RE: Independent Design Consultants Report

# DESIGN CONSULTANT REPORT

# 76 PLACE *at Market East*

Existing Context | Location Plan -Fashion District. Image source: November 2023 CDR submission

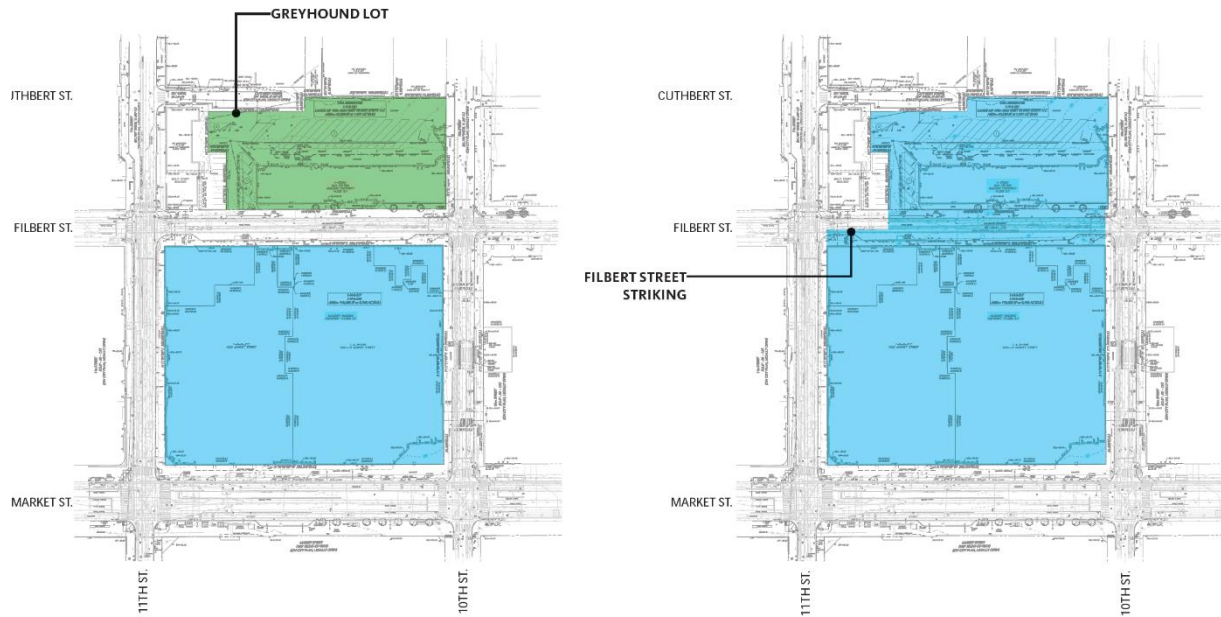
- 3. Site Boundaries:** The Review Team recognizes the extreme difficulty of acquiring and demolishing the parking structure and hotel that exist on the northwest corner of the block bounded by Market Street, 10<sup>th</sup> Street, 11<sup>th</sup> Street, and Cuthbert Street. This fact creates an excluded parcel that constrains the geometry of the arena in some manner. That said, the site proposed for the new arena is barely adequate in size for the proposed use.

*Proposed | Lot Consolidation Plan. Image source: November 2023 CDR submission*

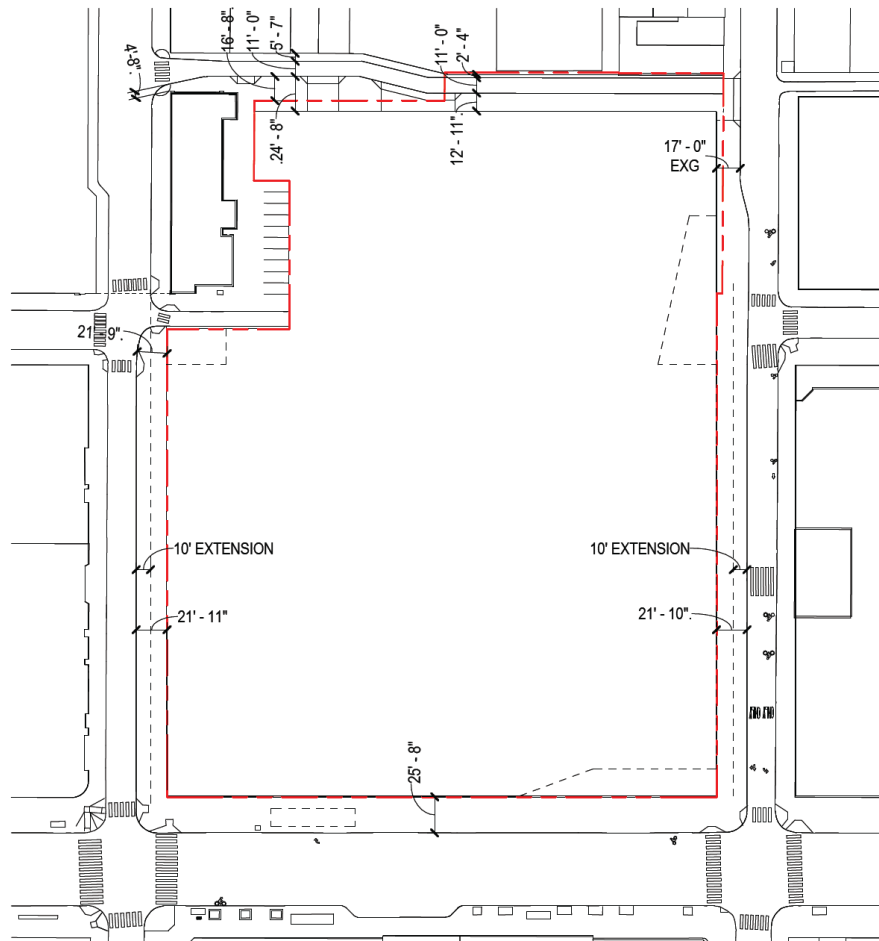
- 4. Striking of Filbert Street:** Vacating of any downtown right-of-way should be done with great caution. We believe that striking Filbert Street is appropriate given the overall dimensions and program for the new arena.

Proposed | Sidewalk Modifications. Image source: November 2023 CDR submission

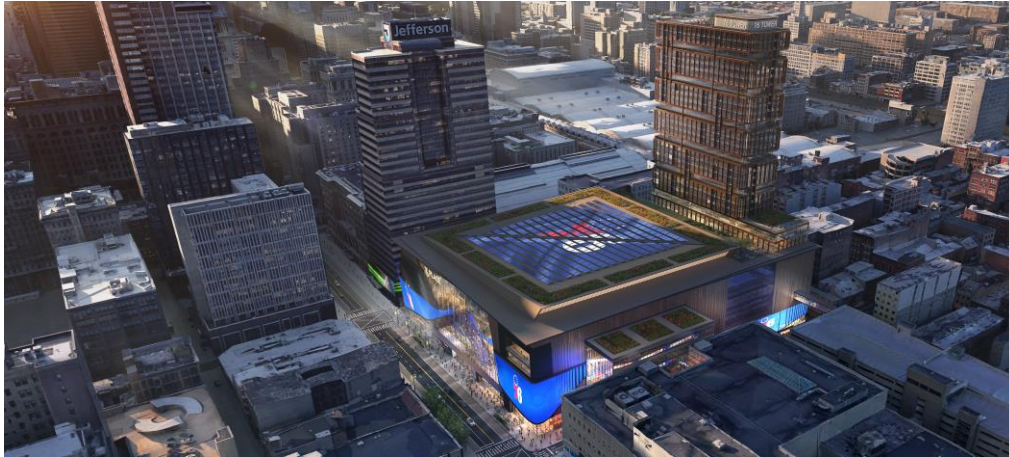
**5. Sidewalk Widening:** The Review Team agrees with the Developer that widening sidewalks on the four streets bordering the new arena (10<sup>th</sup> Street, Market Street, 11<sup>th</sup> Street, and Cuthbert Street) is entirely appropriate and will help to improve pedestrian circulation around the arena on event days. On non-event days, the wider sidewalks will be uncrowded. As to the specific dimensions of the sidewalks, while wider is better, we recognize that, except for Market Street, the existing street rights-of-way are not generous to begin with. We believe the proposed widenings are a reasonable compromise between the need for sufficient pedestrian flow and the need to preserve vehicular movement around the arena. Not widening the sidewalks would be a mistake, in our view.

*Proposed Residential Tower (to right of arena). Image source: November 2023 CDR submission*

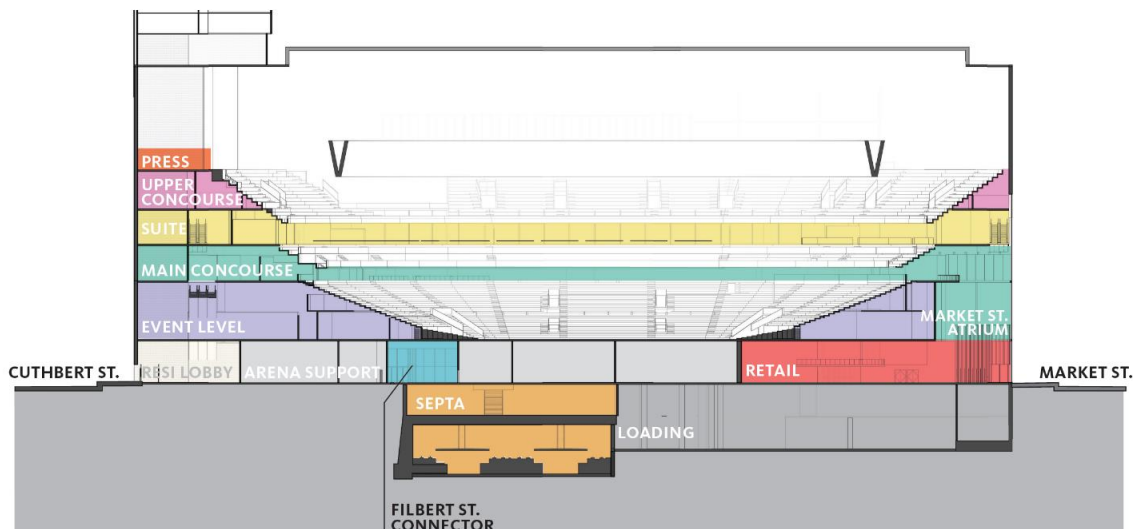
- 6. Residential Tower:** The Review Team commends the Developer for including a residential component in what is already a complex urban framework. We leave it to others to assess the appropriate level of affordable housing in the unit mix, but inclusion of multiple uses increases the urban vitality of the subject parcel by introducing pedestrian traffic at different times of day.

*Proposed Market Street façade. Image source: November 2023 CDR submission*

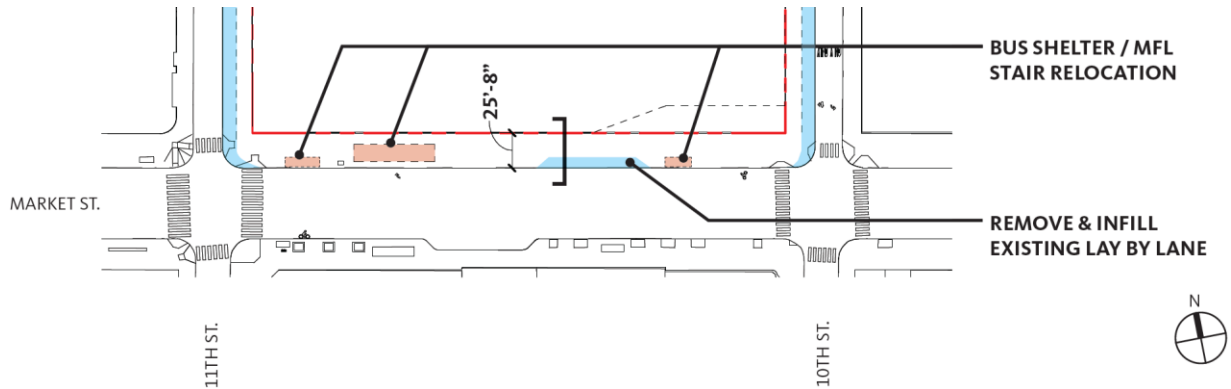
- 8. Transparency:** While the exact configuration of the building facades is still under development, we commend the degree of transparency suggested in the submitted renderings, which will help to activate Market Street, 10<sup>th</sup> Street and 11<sup>th</sup> Street. We also commend the high degree of transparency shown at the 10<sup>th</sup> Street bridge connection to the Fashion District Mall.

*Decluttering Market Street sidewalk. Image source: November 2023 CDR submission*

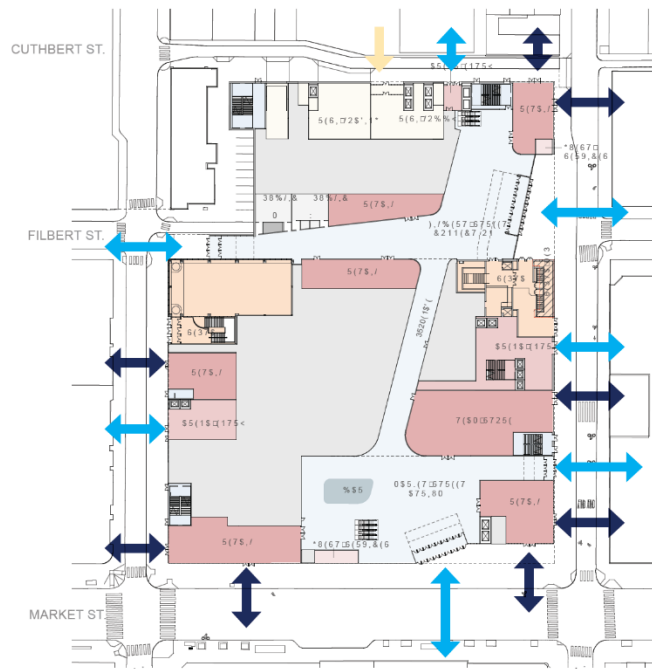
**10. Decluttering Market Street:** We agree that the relocation of transit stops and subway entrances from Market Street between 10<sup>th</sup> and 11<sup>th</sup> Streets adjacent to the arena site is a good idea, creating needed space for event day pedestrian access and flow.

Ground Floor Plan. Image source: November 2023 CDR submission

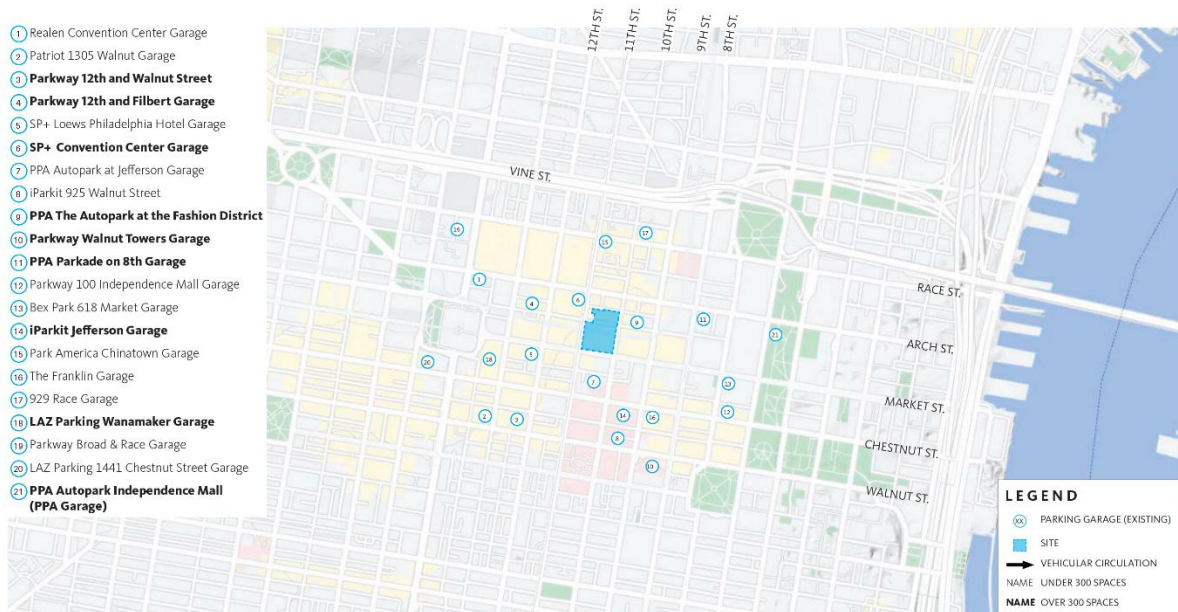
- 1. Ground Floor Plan:** The Ground Floor Plan, as submitted, includes a large amount of undesignated space which presumably is for arena support functions that require grade level access. Given the importance of this level to the overall success of the public realm and urban design, we request that a more complete floor plan be provided.

Proposed Roof rendering. Image source: November 2023 CDR submission

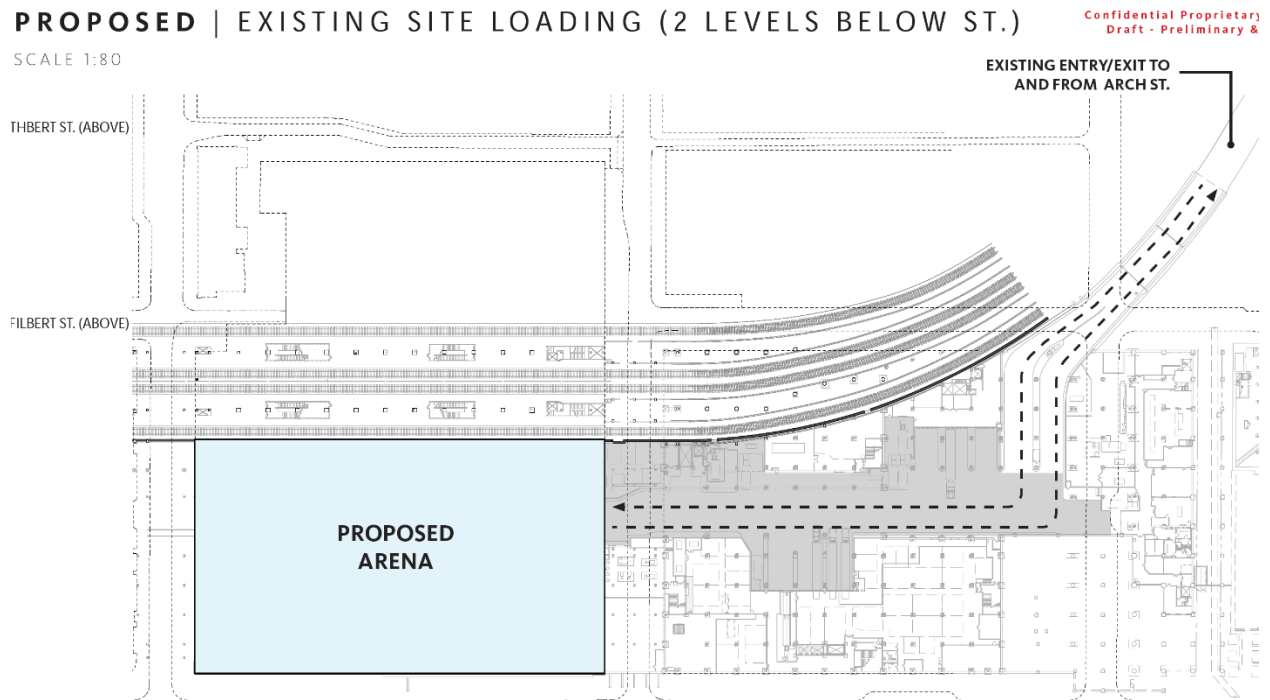
**5. Roof:** No roof plan is provided. The rendering on Page 21 of the CDR submission shows what we assume is a lighted sign facing upwards, and what appears to be plant material, but it is unclear whether there is any occupied space on the roof of the arena.

Circulation | Pedestrian Study Arrival Door Splits. Image Source: November 2023 CDR submission

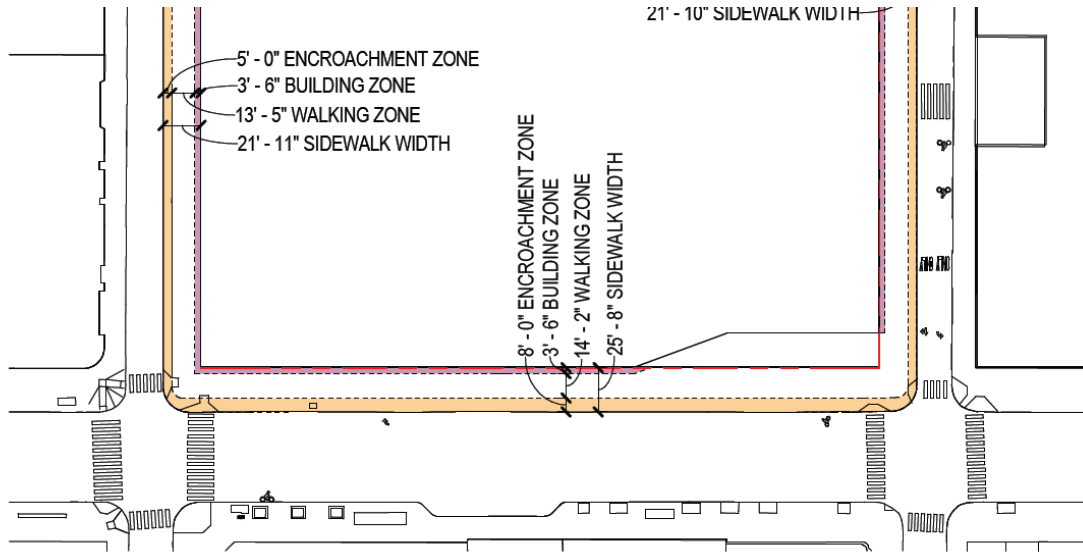
- 3. Structure:** The rendered views are optimistic, in our opinion, regarding the type and amount of structure required to hold up the arena and residential tower. Plans do not show columns for the most part. Our concern is that as structural concerns become more real, the character of the building will change substantially from what is shown in this CDR submission.
- 4. Exterior Surge Space:** While we don't disagree substantially with the estimates of pedestrians arriving at the various entries shown on Page 49 of the CDR submission, we are concerned that the surge space within the property line at 10<sup>th</sup> and Market Streets, as well as at 11<sup>th</sup> and Filbert Streets, is inadequate.

The Review Team would like to see the outdoor surge space at the 11<sup>th</sup> and Filbert Street entrance expanded and the vestibule pushed farther east. Regarding the 10<sup>th</sup> and Market Street entry, we can only observe that more space outside the entry would be better. Entries with lower volumes which propose doors nearly flush with the street wall are less of a concern, although any doors opening into the right-of-way should be recessed or designed to minimize potential conflicts with sidewalk users.

Sidewalk Detail. Image source: March 2024 CDR Submission

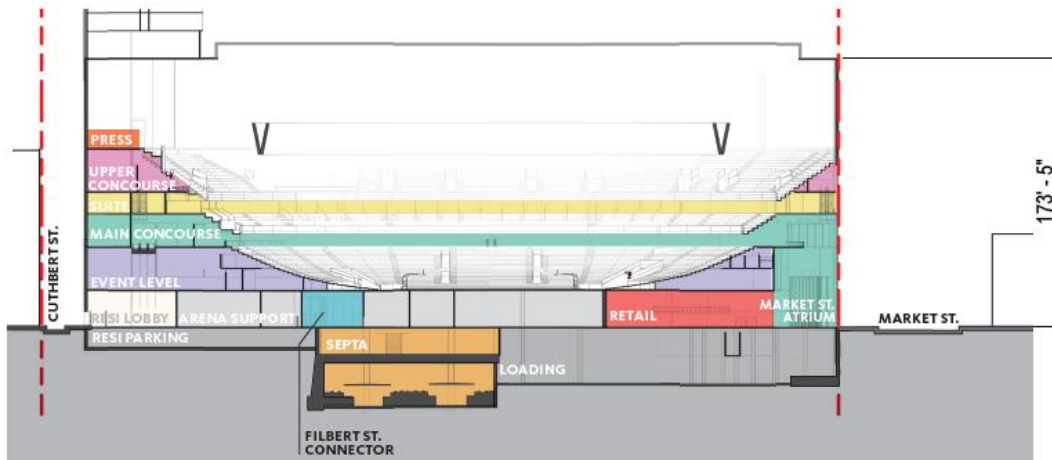
**10. Bike Rack Orientation:** The Design team suggests parallel bike rack parking (to the street) to maximize walking zone widths on all surrounding sidewalks. The Development Team should consider a bollard that is also a bike rack to reduce sidewalk clutter.

Entrance Detail. Image source: March 2024 CDR Submission

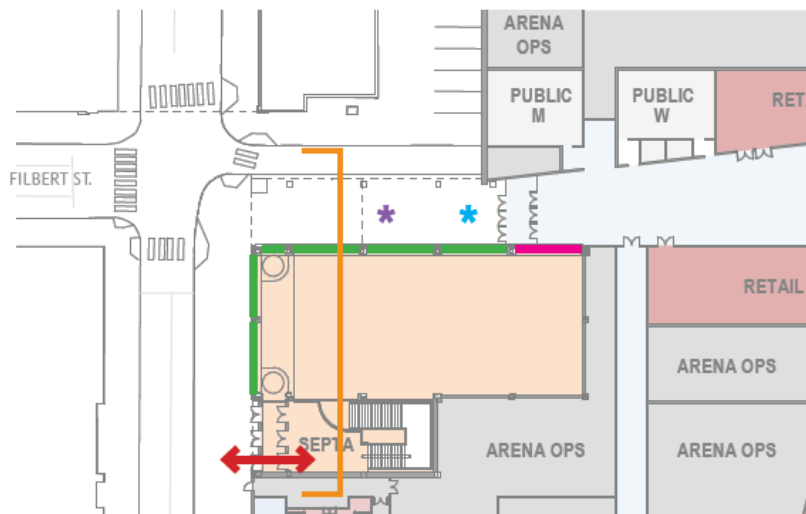
**12. Relocated Filbert Street Entry:** The Review Team notes the revised Filbert Street entrance and door location which are improvements from the prior plan submission in November 2023. This new proposed setback will allow for additional light and air into the SEPTA station and Jefferson Regional Rail Platform.

Section Detail. Image source: March 2024 CDR Submission

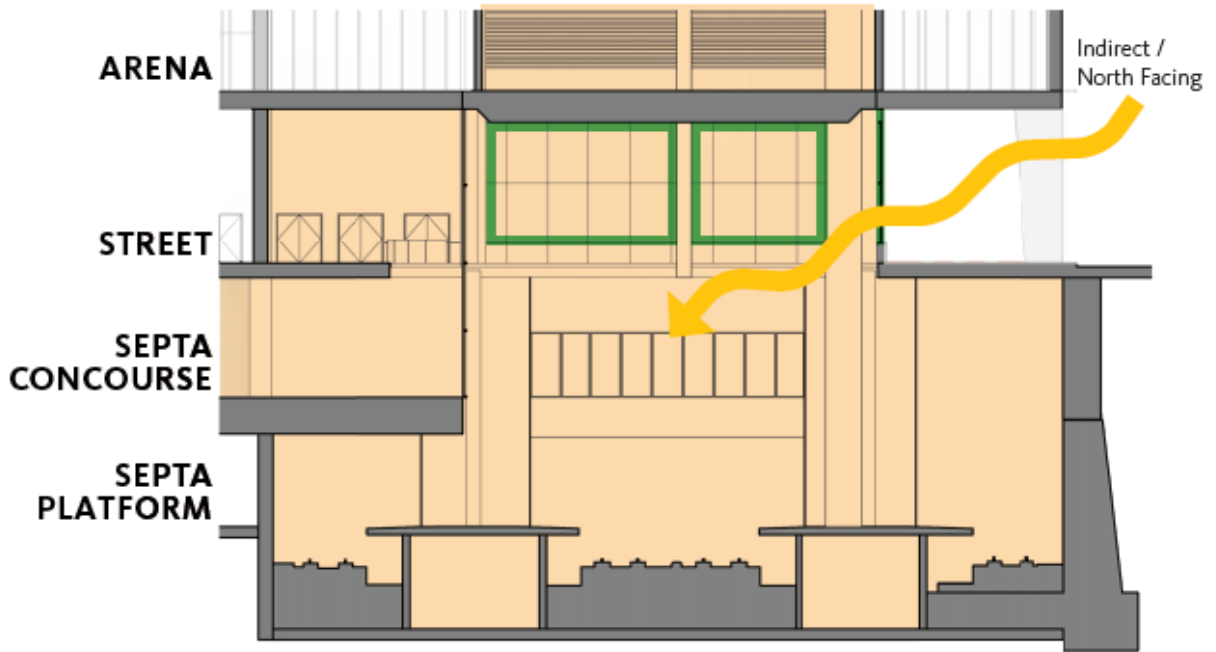
**13. Station Section Drawing:** The “Jefferson Station Atrium Cross Section” is an extremely helpful drawing which shows the relationship of the new building to the SEPTA train platform and how indirect daylight will filter into the platform area. Note that the arrow indicates daylight, but not direct sunlight.

*Event Day Rendering. Image source: March 2024 CDR Submission*

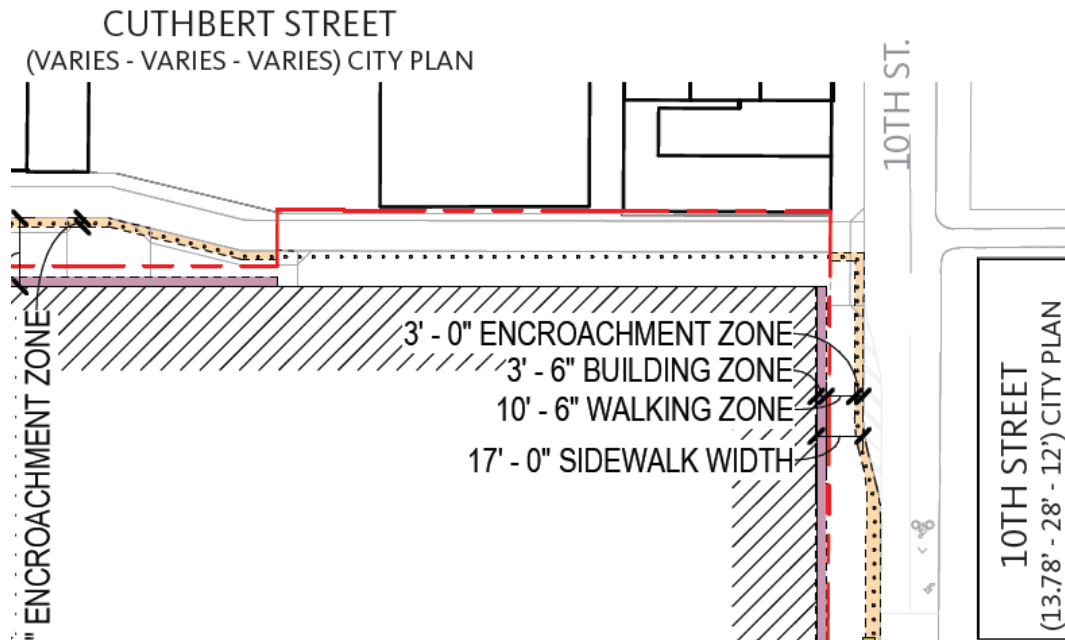
**11. Structural Support:** The Design Review Team still questions what is actually supporting the glass wall (and the arena). Indications of structure are still very notional and unconvincing.

Sidewalk Plan Detail. Image source: March 2024 CDR Submission

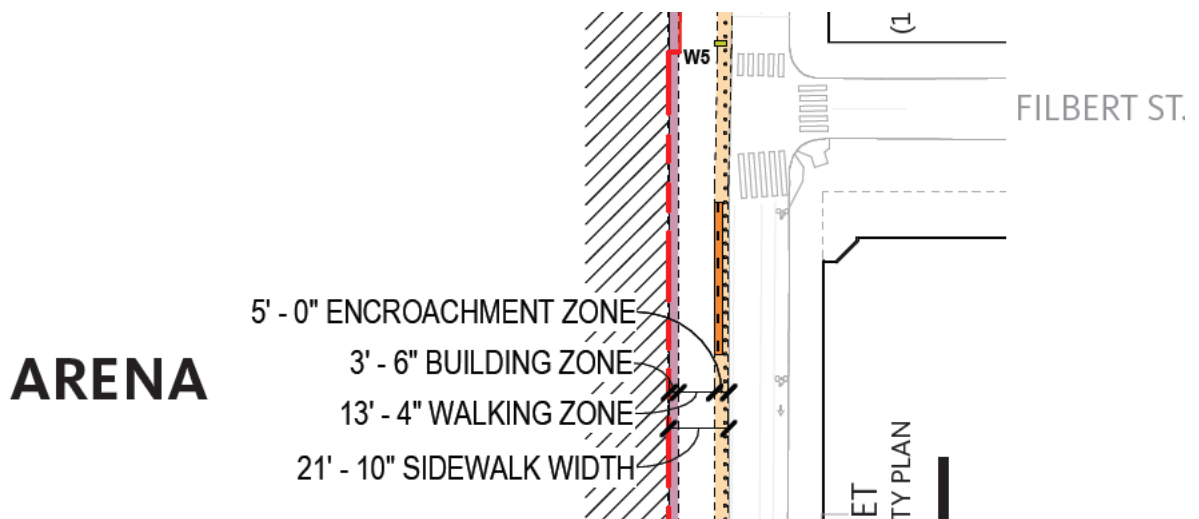
**14. Sidewalk dimensions:** There is minimal sidewalk width along portions of Cuthbert Street. More information is needed regarding the proposed elevation and the residential/arena ingress and egress. Is this space also intended for short term loading functions?
